# GLENORCHY PLANNING AUTHORITY

## AGENDA

MONDAY, 8 MAY 2017

**5. PROPOSED USE AND DEVELOPMENT - SEVEN (1 EXISTING AND 6 NEW) MULTIPLE DWELLINGS - 14 PARINGA ROAD AND 1 MOORE PARK DRIVE, GLENORCHY**

**Figure 1: Proposal Plans – Site Plan - Wilson Homes**

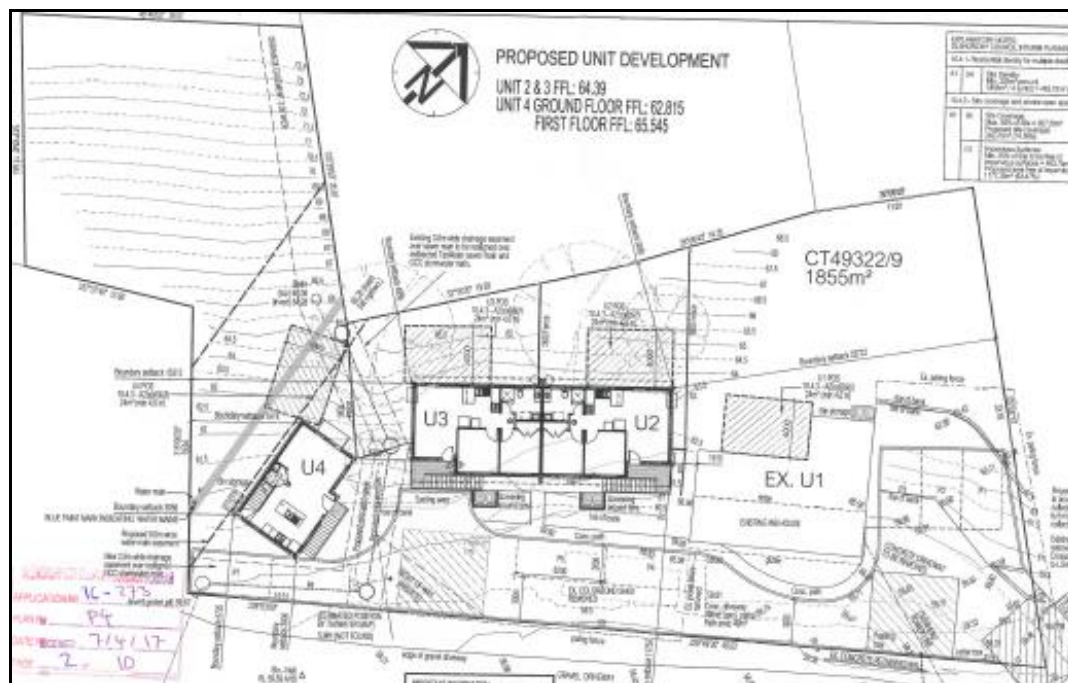
The proposal would require nine spaces in accordance with the above table. However, it is proposed to provide for seven spaces. The proposal therefore relies on the related Performance Criteria which is as follows:

The application is *discretionary* as it relies on Performance Criteria in relation to the building envelope and has a shortfall of two parking spaces. It is assessed that the proposal would not adversely affect any neighbouring property in terms of overshadowing, loss of sunlight or visual bulk. In regards to the parking shortfall, it is considered due to site constraints that it is not possible to provide more parking. The proposal meets the Performance Criteria as there would be on-site parking and public transport available.

1. Use and development shall be substantially in accordance with planning permit application No. PLN-16-273 and Drawing No. P4 submitted on 07/04/17, except as otherwise required by this permit.

Figure 2: Proposal Plans - south and east elevation - Units 2 & 3 - Wilson Homes

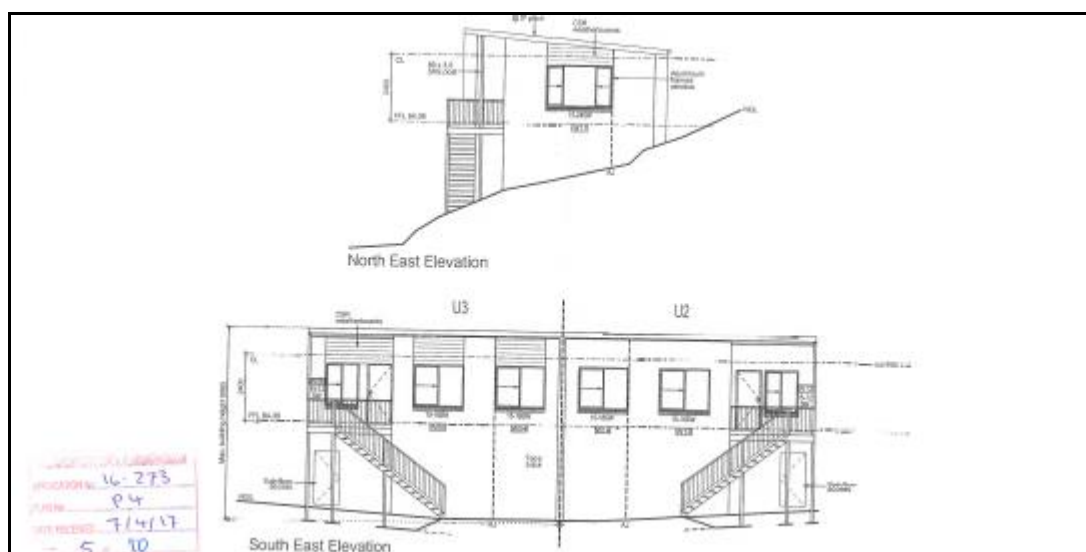
The application is *discretionary* because the south corner steps within the setback distance and because there is a shortfall of two parking spaces.

The application does not accord with the Acceptable Solution in 10.4.6 A1 (c) because there are no screens shown on the plan and because there are not the required separation distances as follows:

4. The window of the northeast elevation of Unit 2 must be reduced in size to have a sill height of at least 1.7 m above the floor level so as to prevent overlooking. The plans submitted in association of a Building Permit Application must show this requirement to the satisfaction of Council's Senior Statutory Planner.

5. A permanently fixed screen to a height of at least 1.7 m above the finished surface or floor level with a uniform transparency of no more than 25% must be installed on the southwest side of the landing of Unit 3 and on the northeast side of the landing of Unit 2 to prevent overlooking. The screen must be installed prior to issue of a Certificate of Occupancy and must then be maintained for the life of the use. The screen must be shown on plans submitted in association with a Building Permit Application to the satisfaction of Council's Senior Statutory Planner.
